Amendments to the Drawings

Attorney Docket No. 127976-1000

App. No.: 10/664,737
Reply to Office Action of 12/07/04
Annotated Sheet Showing Changes

FIG. 1

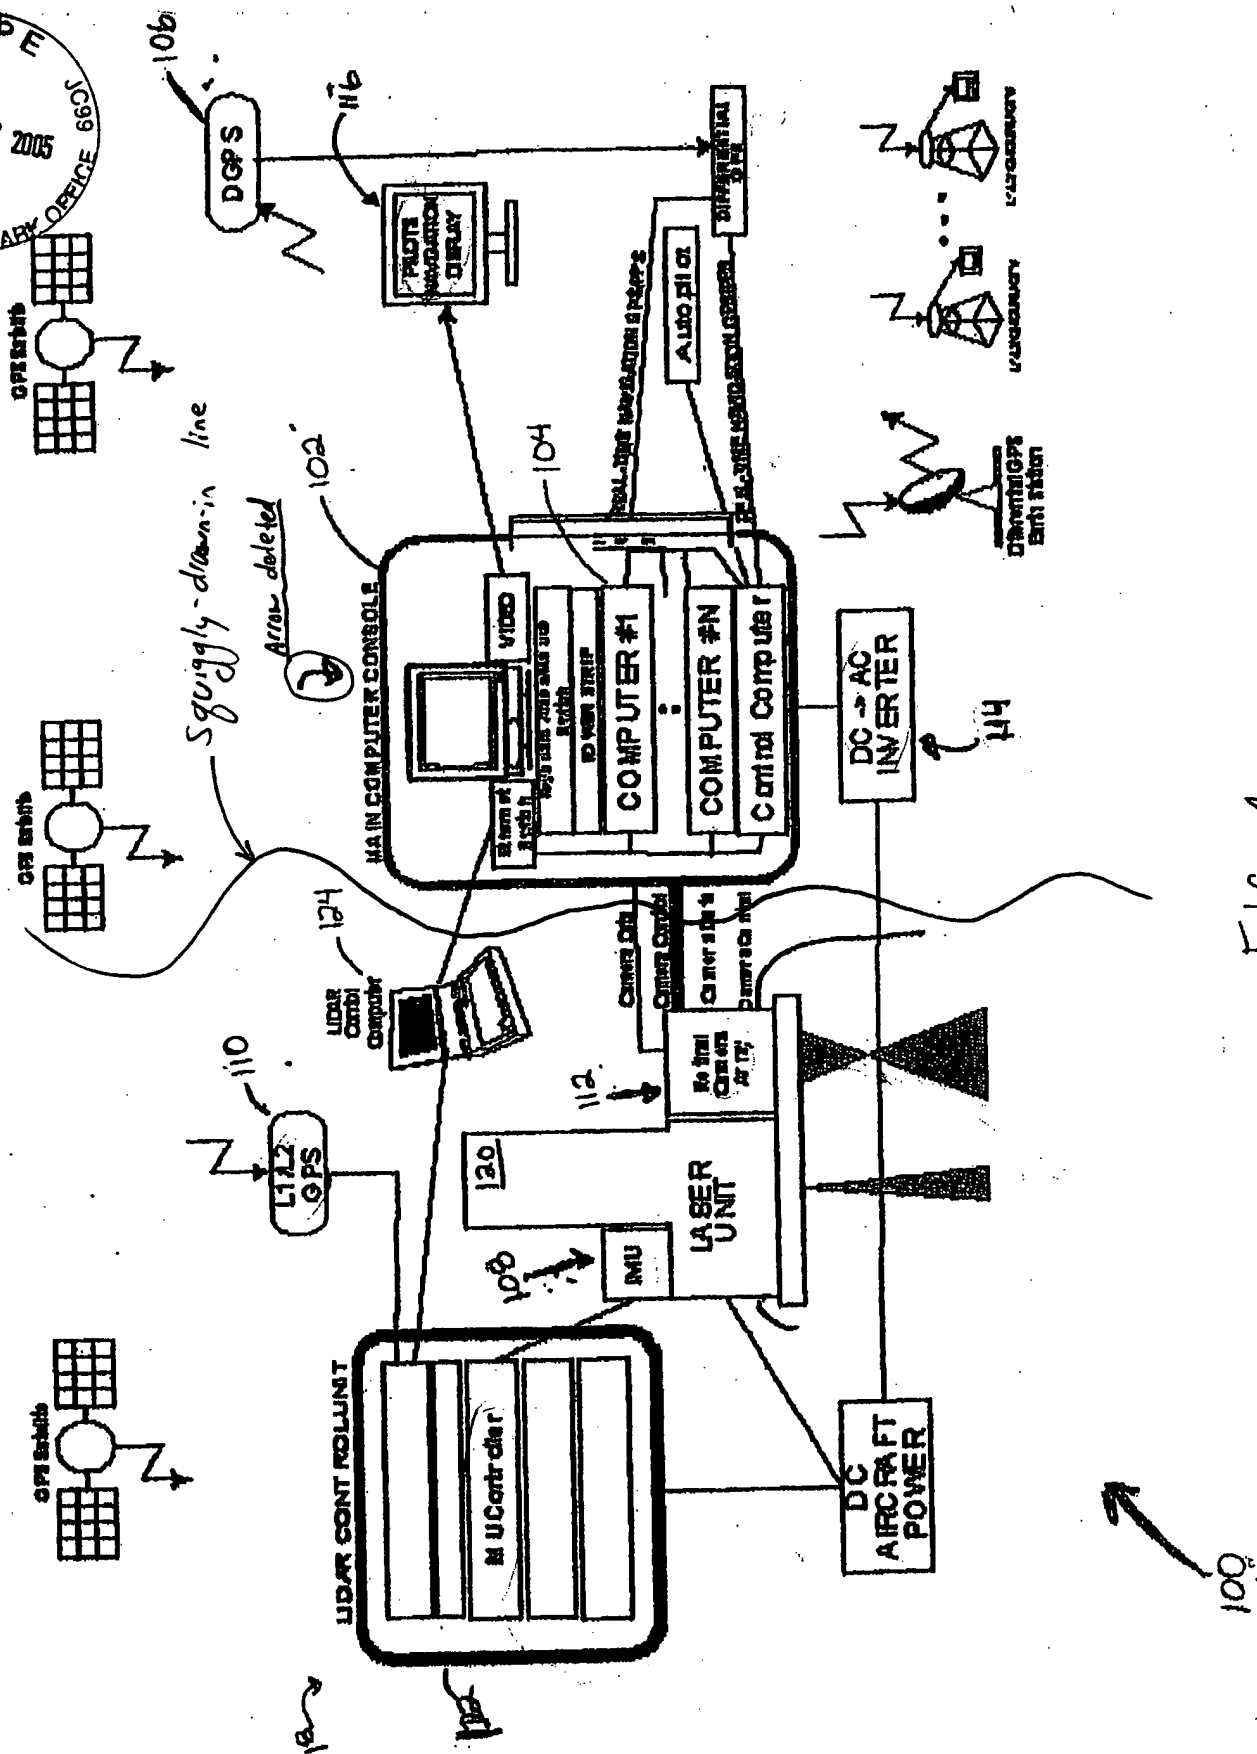
The attached sheet of drawings includes changes to Figures 1-18. The sheet that includes Figure 1 now replaces the original sheet that included Figure 1. In Figure 1, the lines connecting and identifying certain representational components have been repositioned for reasons of clarity. In Figure 1, the shape of the boxes have been changed and repositioned for reasons of clarity and stylistic preference. Additionally, Applicant has deleted some of the words in Figure 1, without prejudice and for reasons of clarity. No new matter has been added to Figure 1. Additionally, the arrow pointing to the block previously labeled “main computer console” has been deleted. Accordingly, Applicant respectfully requests the withdrawal of the objection to Figure 1.

In this application, Applicant has added new Figure 1A. Support for new Figure 1A is in the portion to the right of the squiggly-drawn-in line in annotated Figure 1. No new matter has been added to the specification as originally filed by including new Figure 1A.

In this application, Applicant has added new Figure 1B. Support for new Figure 1B is in the portion to the left of the squiggly-drawn-in line in annotated Figure 1. No new matter has been added to the specification as originally filed by including new Figure 1B.

FIG. 2

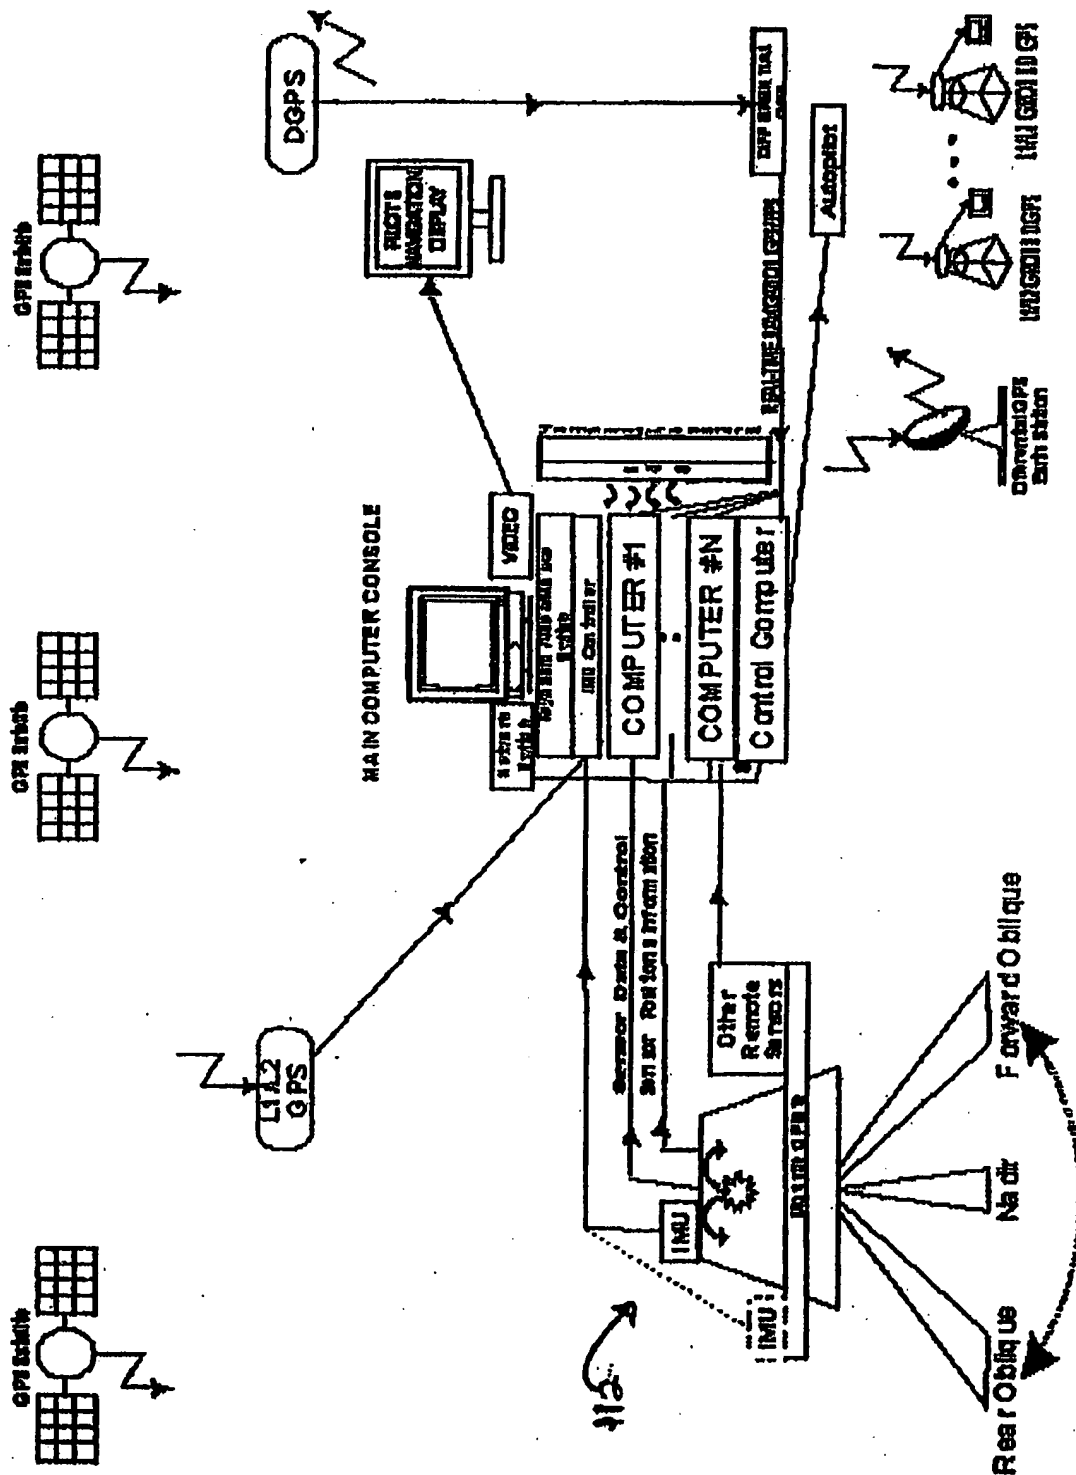
The sheets that includes Figure 2 now replaces the original sheet that included Figure 2. In Figure 2, the lines connecting and identifying certain representational components have been repositioned for reasons of clarity. No new matter has been added to Figure 2.

FIG. 3

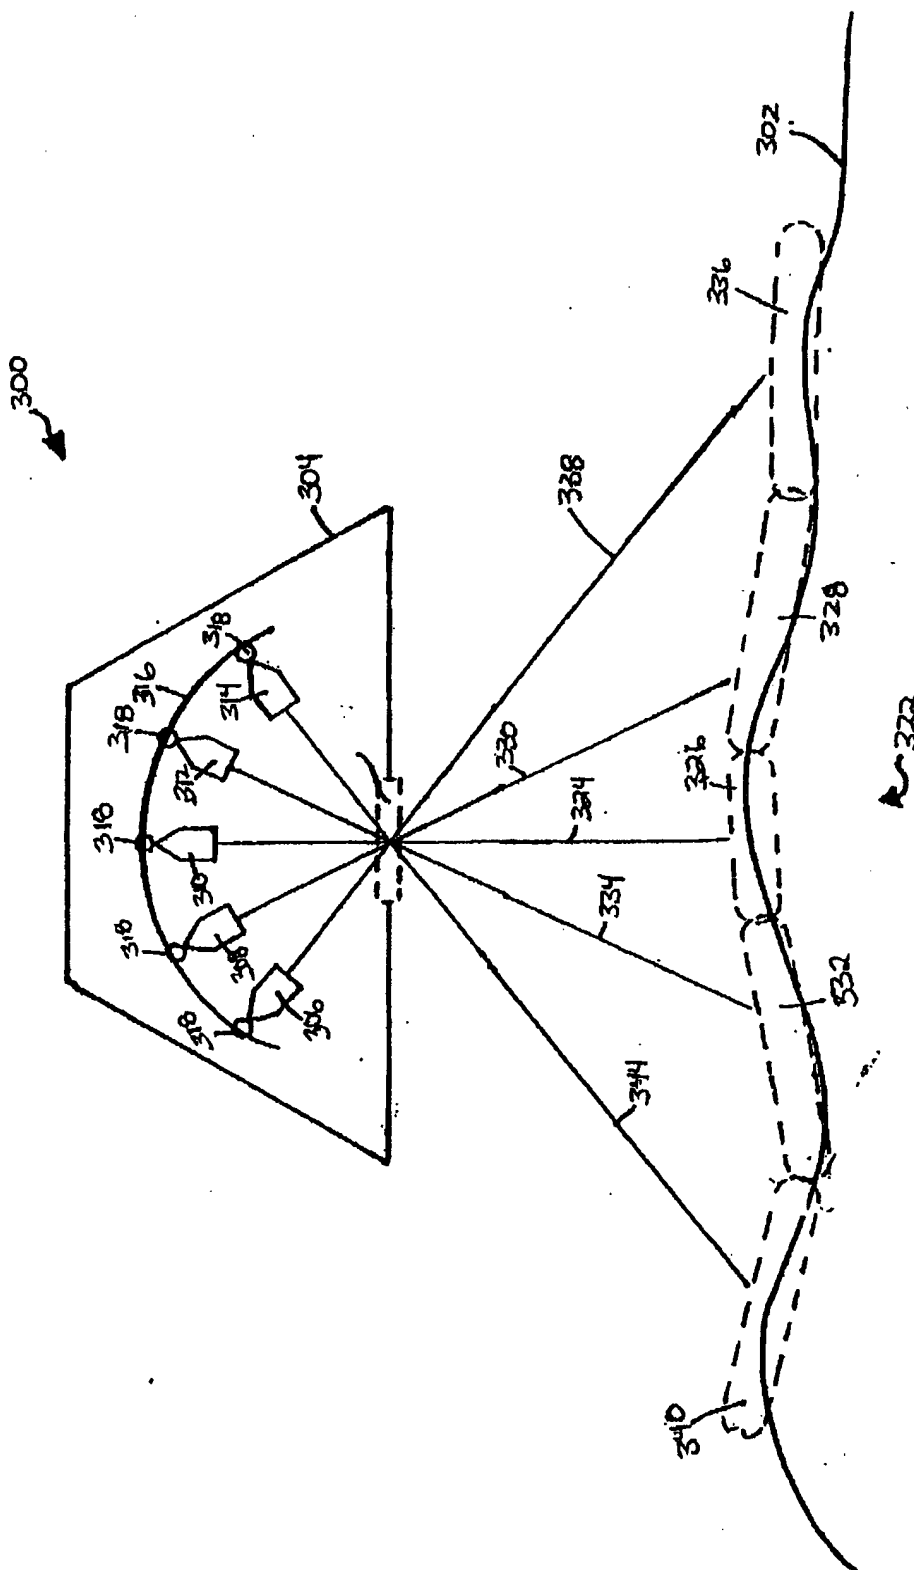
The sheets that includes Figures 3 and 4 now replaces the original sheet that included Figure 3 and the original sheet that included Figure 4. In Figures 3 and 4, the lines connecting

and identifying certain representational components have been repositioned for reasons of clarity. No new matter has been added to Figures 3 and 4.

FIG. 6

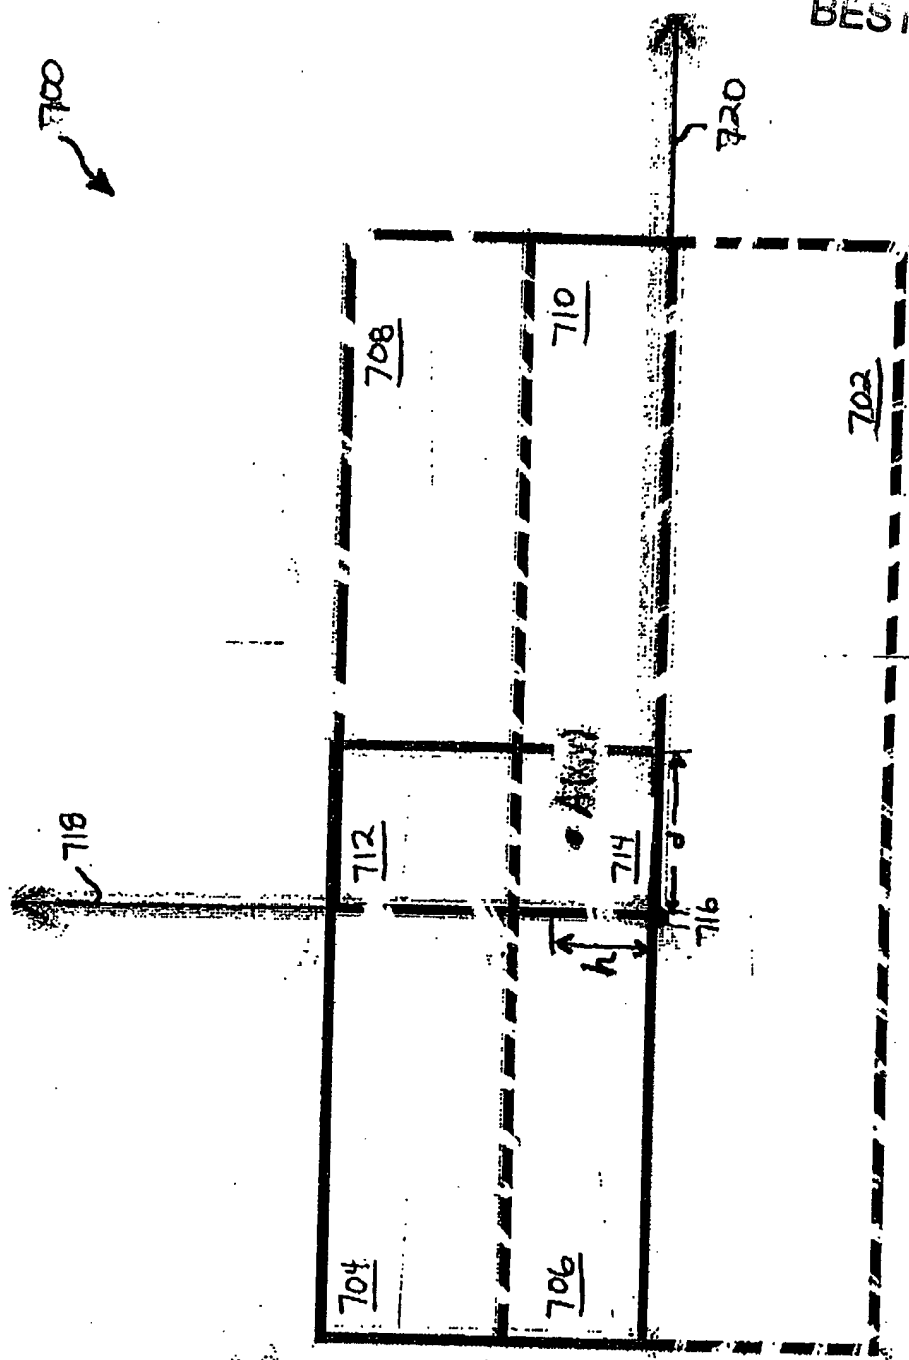
The sheets that includes Figures 6 and 7 now replaces the original sheet that included Figure 6 and the original sheet that included Figure 7. In Figures 6 and 7, the lines identifying certain representational components have been repositioned for reasons of clarity. No new matter has been added to Figures 6 and 7.

FIG. 8

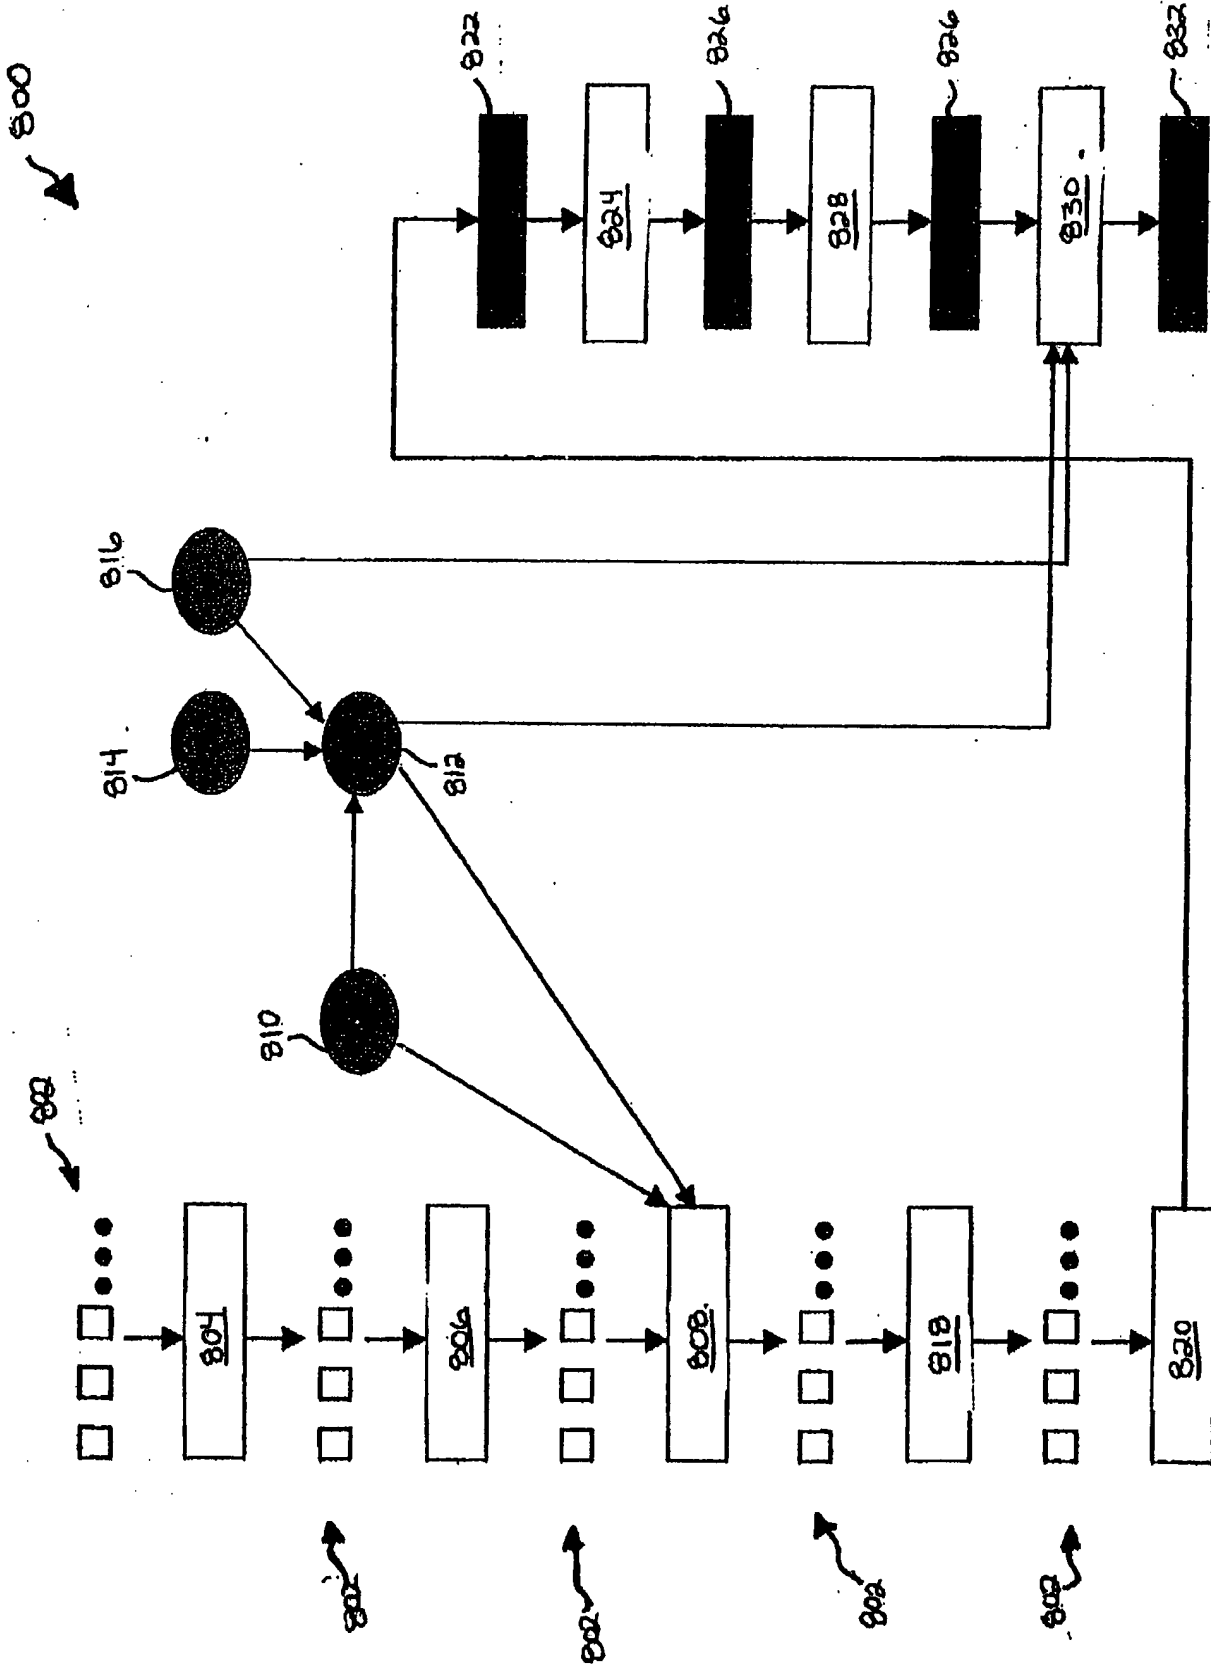
The sheet that includes Figure 8 now replaces the original sheet that included Figure 8. In Figure 8, the lines identifying certain representational components have been repositioned for reasons of clarity. No new matter has been added to Figure 8.

FIGURE 10

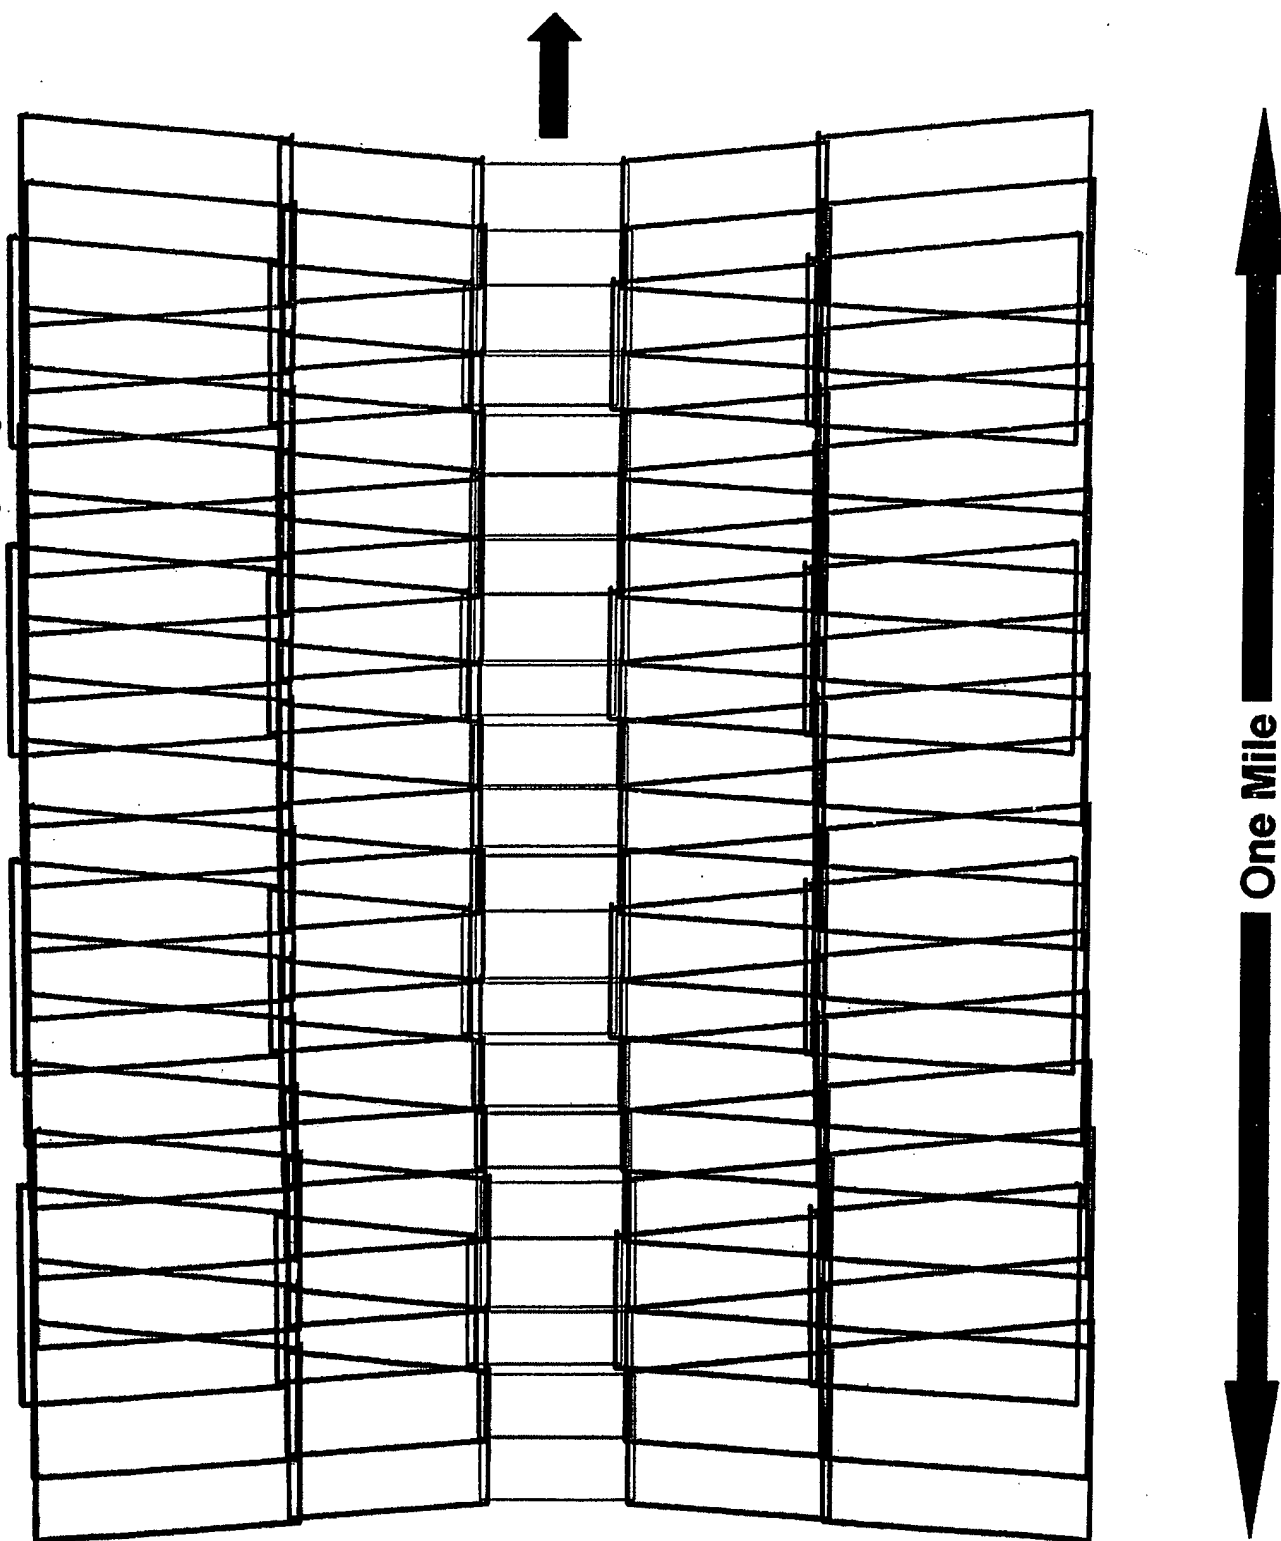
The sheet that includes Figure 10 now replaces the original sheet that included Figure 10. In Figure 10, the lines connecting and identifying certain representational components have been repositioned for reasons of clarity. In Figure 10, the shape of the boxes have been changed and repositioned for reasons of clarity and stylistic preference. Additionally, Applicant has deleted

some of the words in Figure 10, without prejudice and for reasons of clarity. No new matter has been added to Figure 10.
